IMPROVEMENT ON PRODUCT	HERCULES VII 250 t
PART NUMBER	RG00574/RG00576

As part of our continuous improvement program, we have made the following changes:

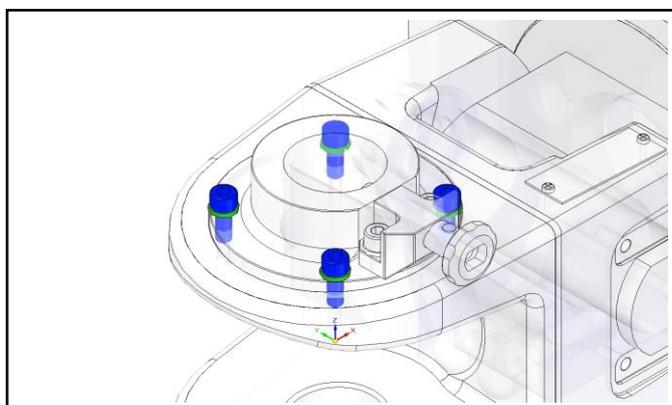
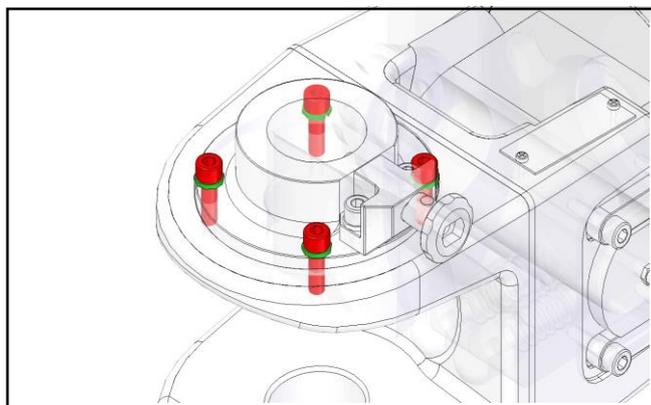
The 2 above mentioned kits (RG00574 and RG00576) now includes new type of screws:

1. New screws are 5mm longer compared the previous ones
2. New screws have a better material class: from 8.8 to 10.9
